Preliminary Site Plan

Mountain Walk Townhomes

PETITION NO: Z-10
HEARING DATE (PC): 02-03-15
HEARING DATE (BOC): 02-17-15
PRESENT ZONING: CRC, HI
PROPOSED ZONING: RM-8

ZONING COMMENTS:

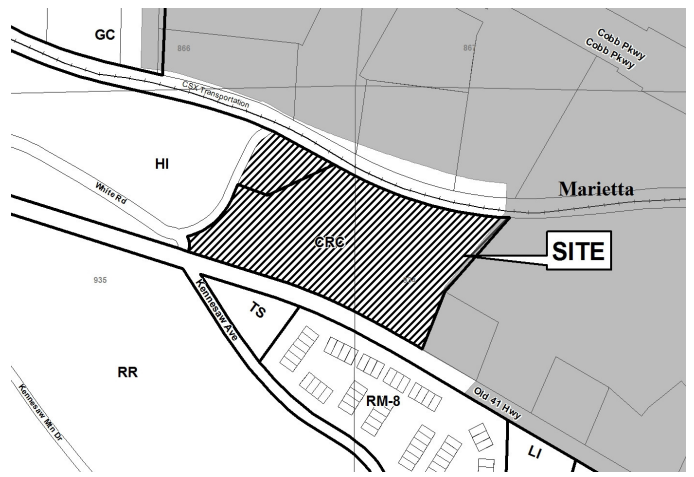
The submitted plan demonstrates a reduction in the rear setback from the required 30 feet to 25 feet adjacent to the CSX Railroad. Also, the applicant is presenting increased setbacks on the sides from 15 feet to 35 feet with 25 foot buffers.

- No Stormwater controls shown _____
- Copy of survey is not current – Additional comments may be forthcoming when current site conditions are exposed.
- No site improvements showing on exhibit.
